**Landscape Review Committee**  
**Hybrid In-Person & ZOOM Online Meeting**  
**Wednesday, December 17, 2025 - 12:00 PM**

**DATE:** December 17, 2025  
**TO:** Landscape Review Committee Members  
**FROM:** Taylor Graybehl, Senior Planner  
**SUBJECT:** Landscape Plan Review Application L 25-25

**DOCKET:** L 25-25 (Landscape Plan Review and Street Tree Plan)

**REQUEST:** Approval of street tree plan, and a landscape plan review of the open space tract in "Dunn Place" Planned Division Amendment, Subdivision, and Three Mile Lane Review (PDA 1-23, S 1-23, TML 5-23). The applications are submitted to address the conditions of approval.

### Figure 3. Street Tree Plan

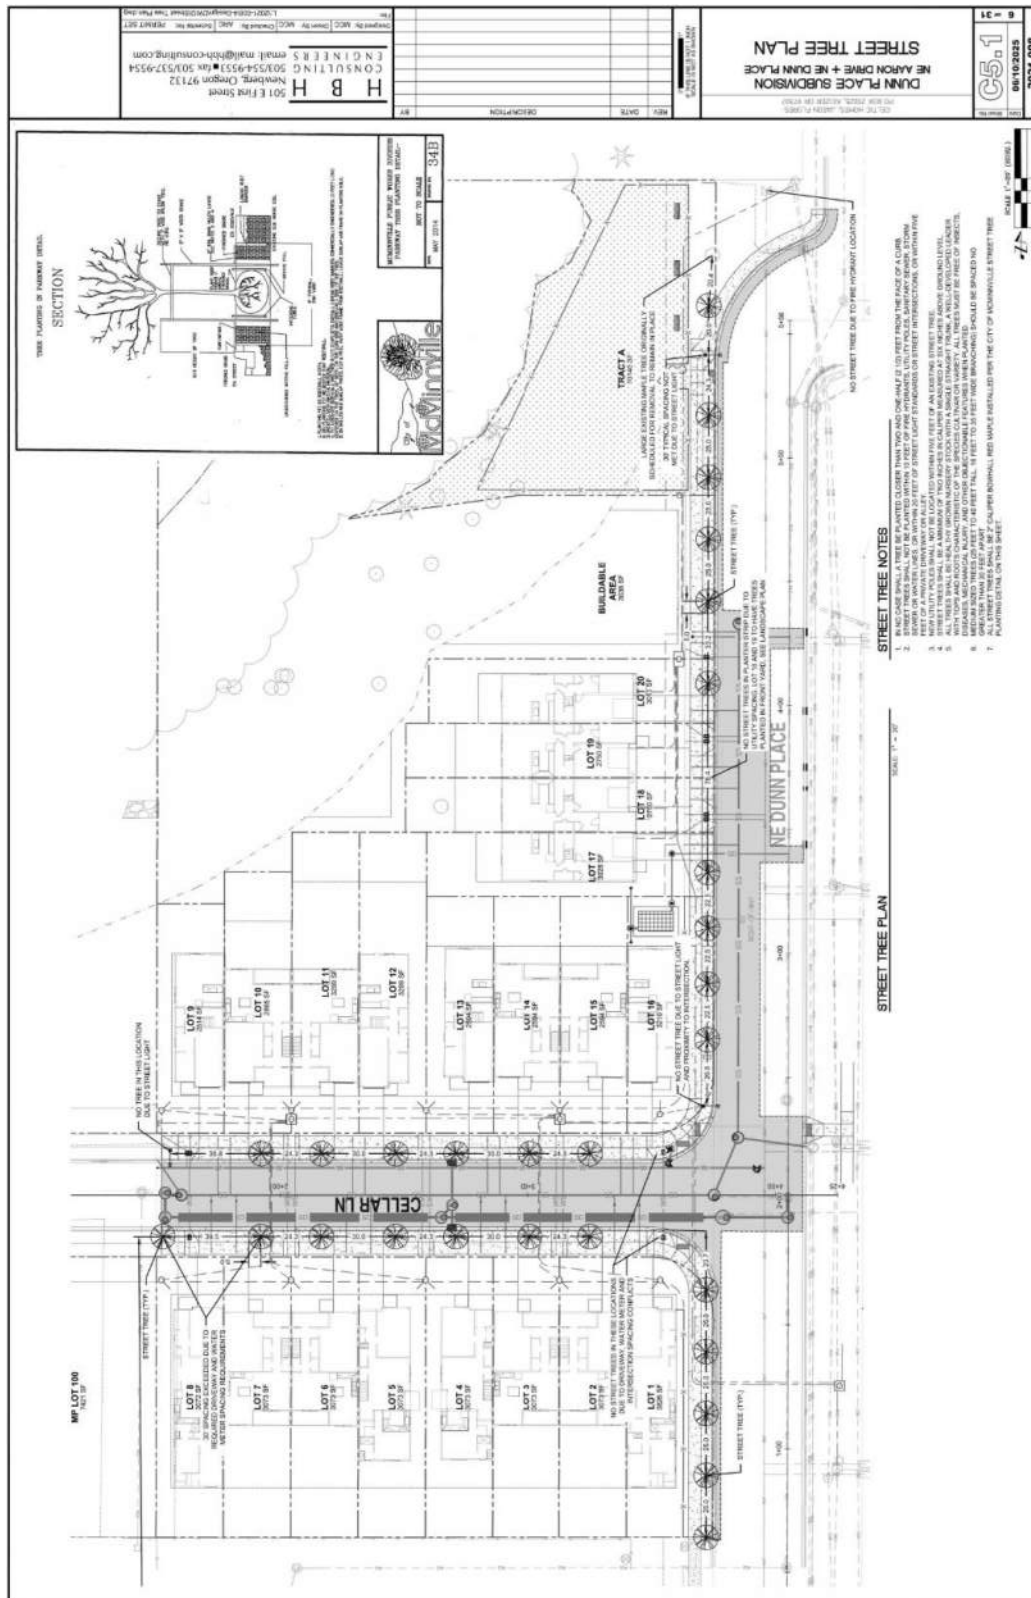
7. Prior to final plat, the applicant shall submit a revised street tree plan with the tree species changed to one identified as "large" from the McMinnville Street Tree List, where trees are spaced more than 30 feet from a neighboring tree. Those trees to be revised include those in front of lot(s): 2, 7, 8, 10, 15, 16 (nearest to the corner), 17, 20, and the tree in front of the "buildable area" that is identified 33.2 feet away from the tree on lot 20.

Figure 4. Landscape Plan (ENLARGED)

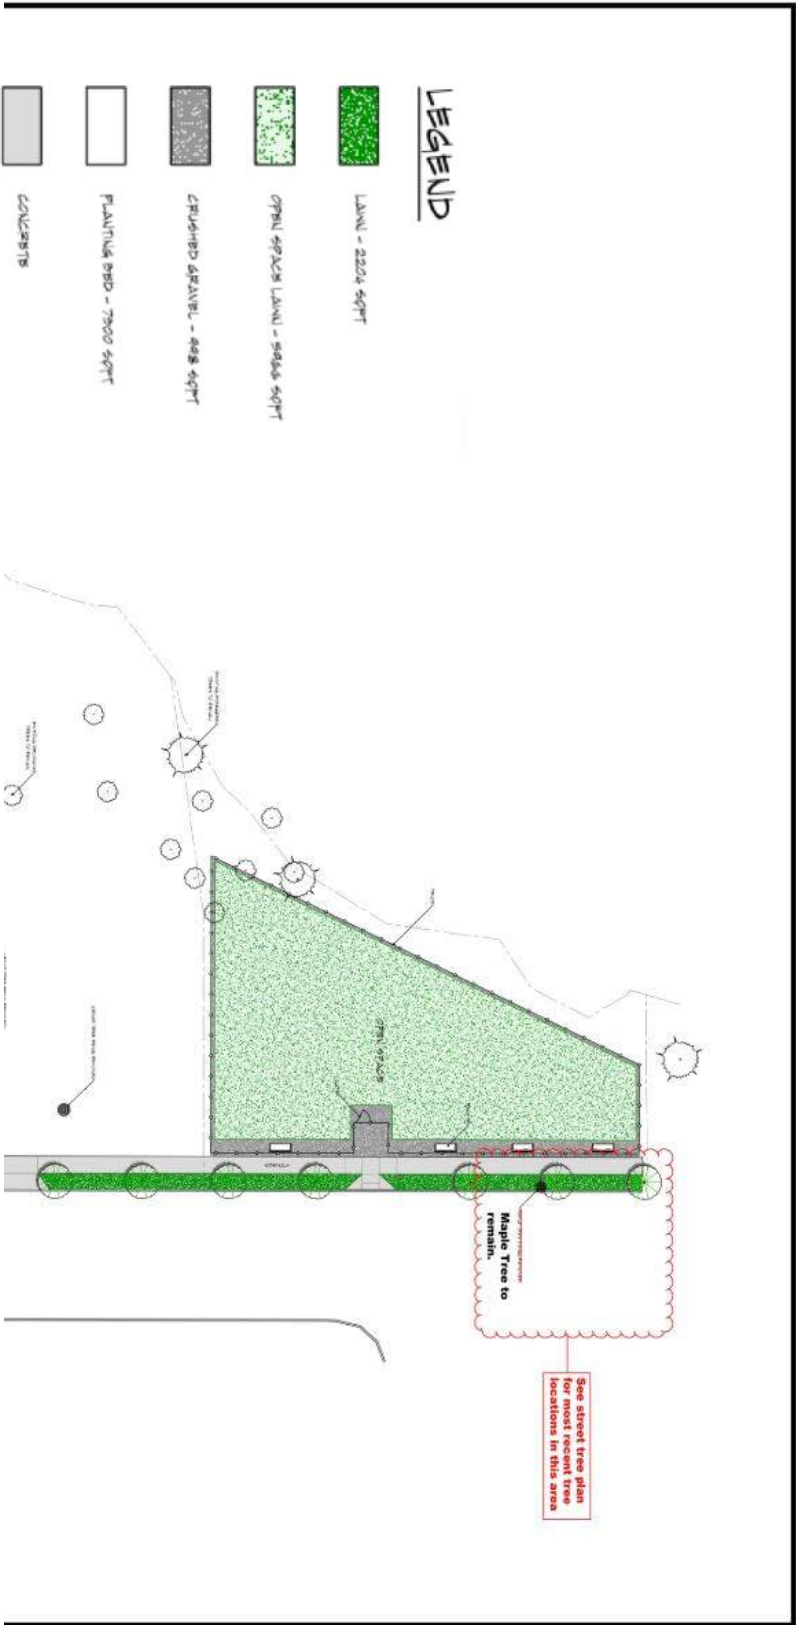
5. Prior to final plat, the applicant shall submit a revised landscape plan in conformance with MMC 17.57.060 with the following revisions:
  - a. Match the street configuration of the approved plans for Dunn Place.

11. Prior to final plat, the applicant shall submit a revised landscape plan that provides at least four of the options provided in MMC 17.11.110(C)(4).

12. Prior to final plat, the applicant shall submit a revised landscape plan designed to meet Policies 5, 7, and 20 of the Three Mile Lane Area Plan (Ordinance No. 5126).

DESIGNED BY:	BNF
DRAWN BY:	BNF
MANAGED BY:	MTS
CHECKED BY:	KAH
DATE:	11/3/25
REVISIONS	
JOB NUMBER <b>5147-02</b>	
SHEET <b>C119</b>

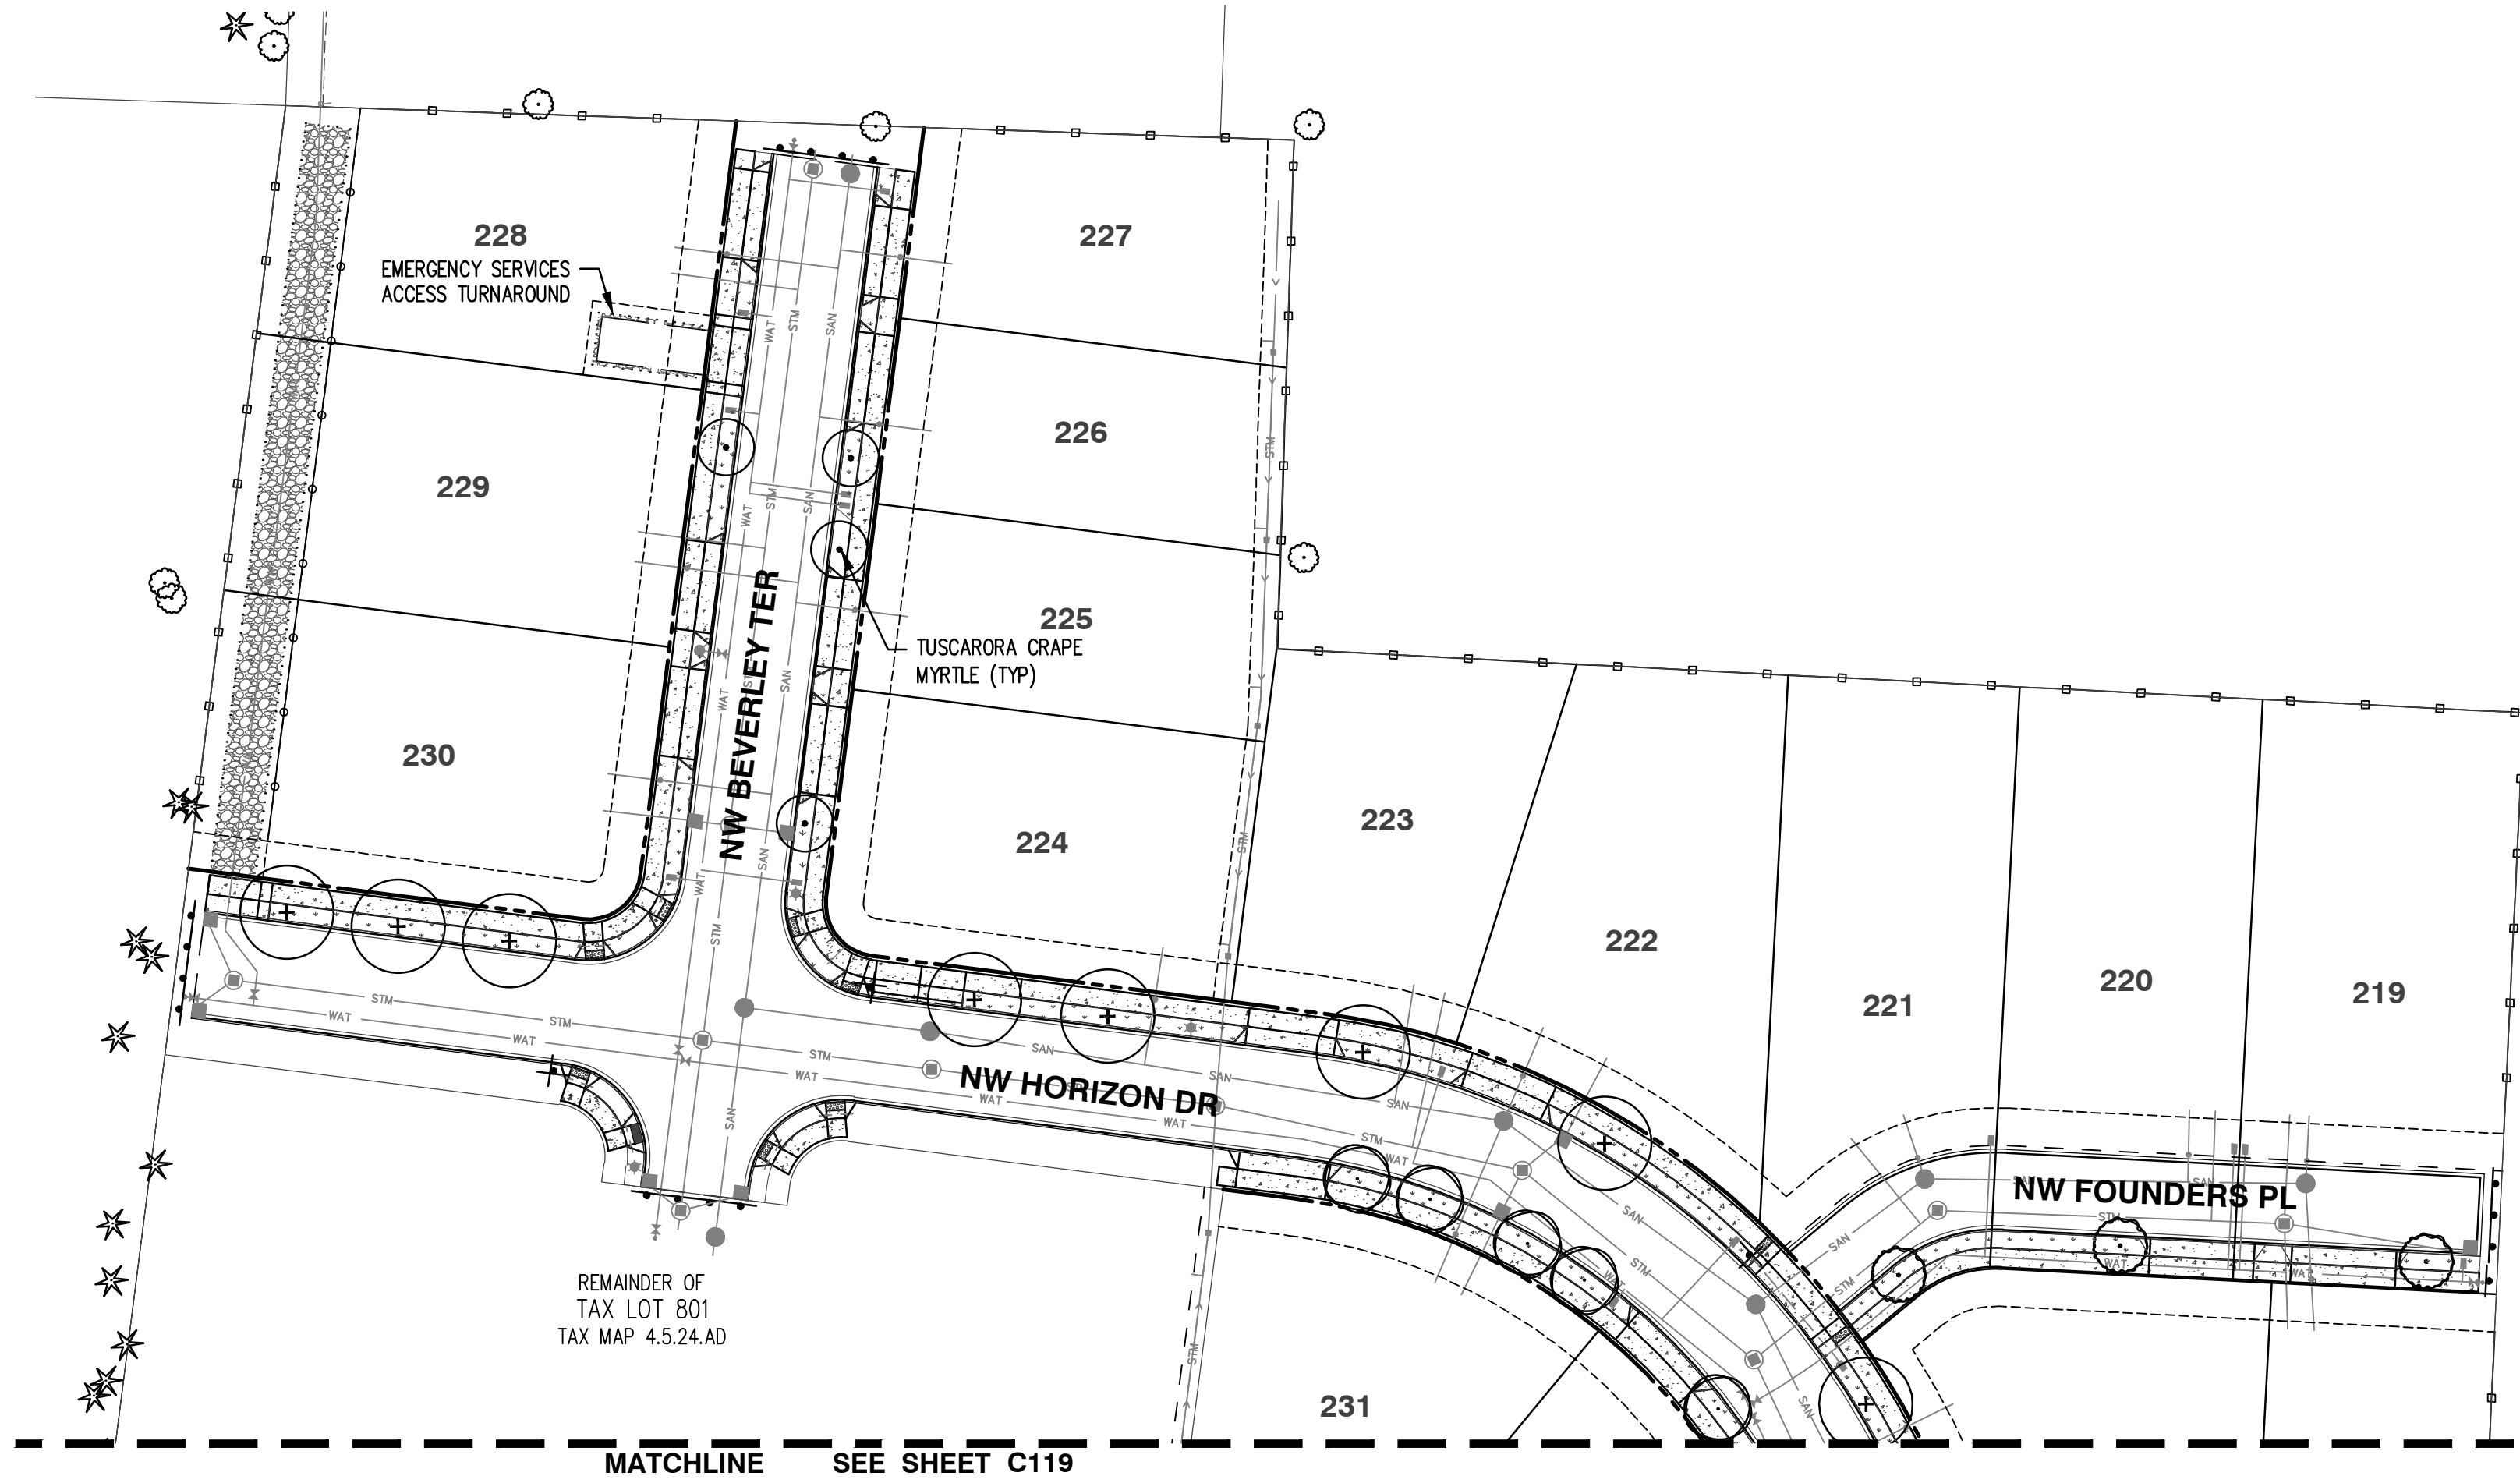
- ii. The applicant shall update the street tree planting specification in the plan set (on Sheet C120) to the City's current specification. Please see the City's August 2025 standard drawing 34B. This current specification provides for the root barrier along the back of curb and along the sidewalk to be 10 feet in width centered at the street tree, deep watering tubes, and staking.
